Fab & Install: Corner Blade Sign

Project Address:  
J. Jeffers / Journal Square  
333 W State Street  
Milwaukee, WI 53203

### J. Jeffers Journal Square MATC Westown Green Blade Sign - 6, BL6

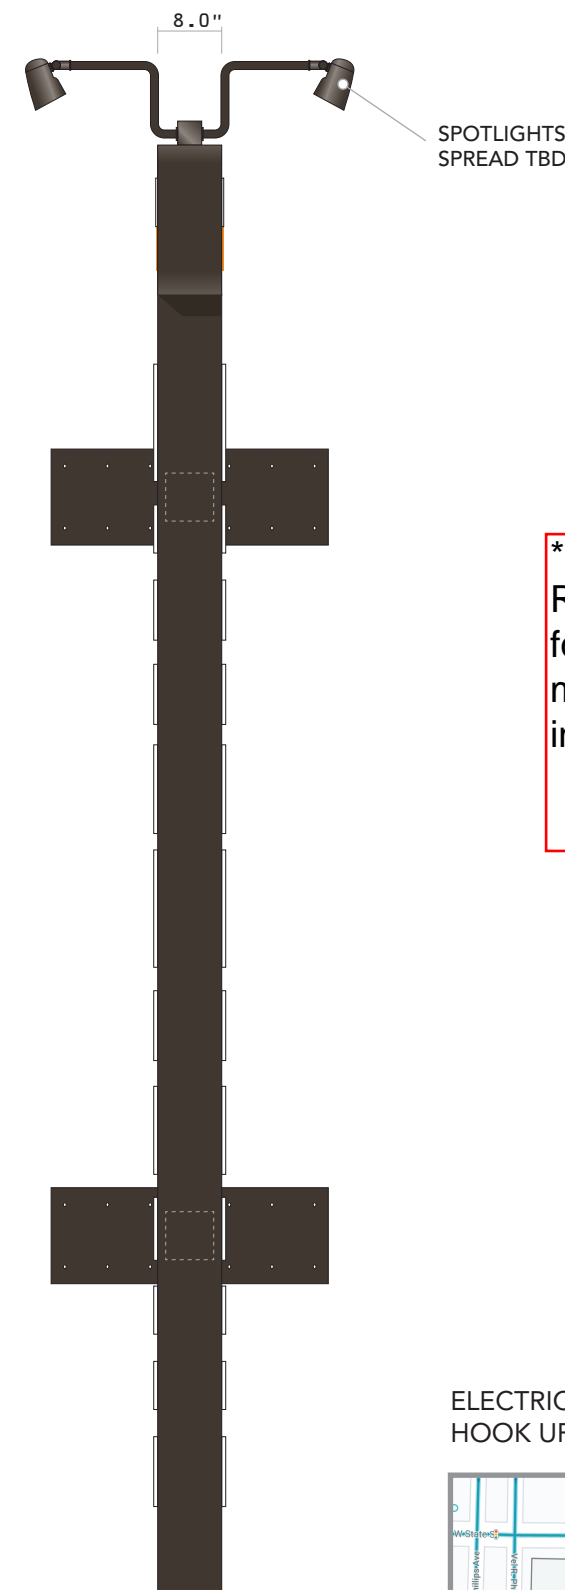
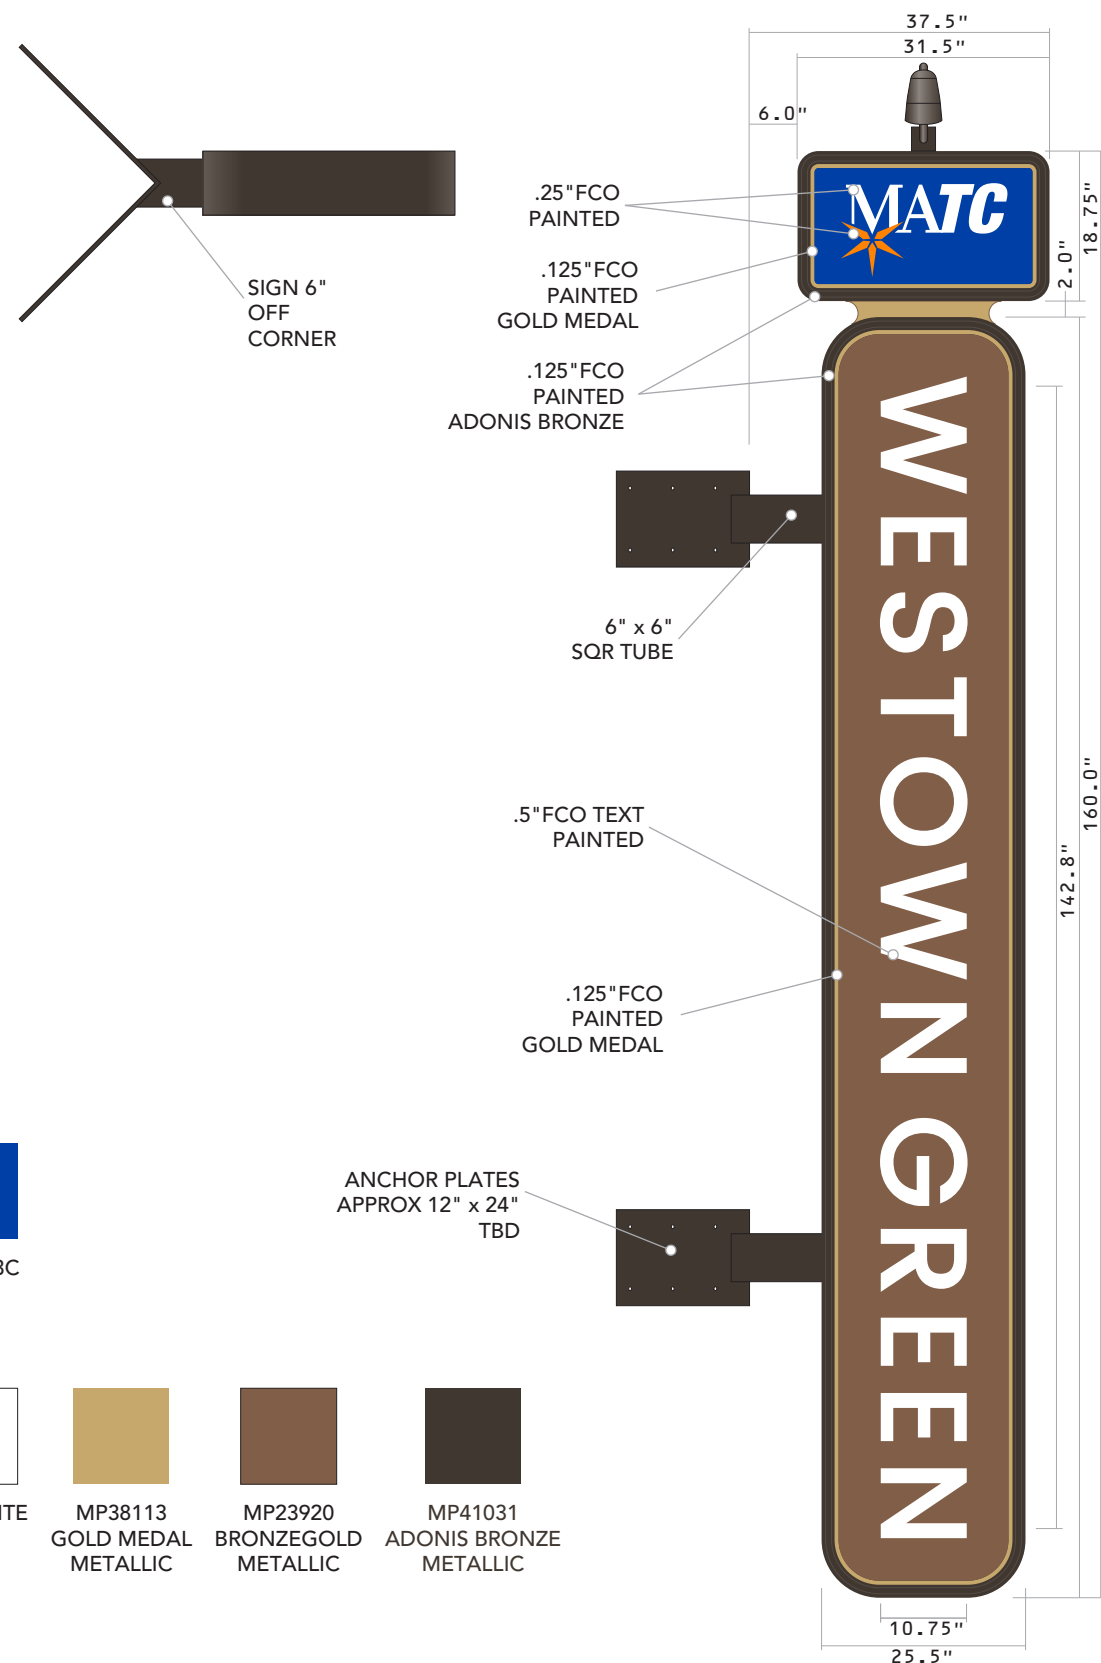
**\*5/5/23 JB**  
Reference HPC criteria  
for sign placement and  
mortar line for  
installation.
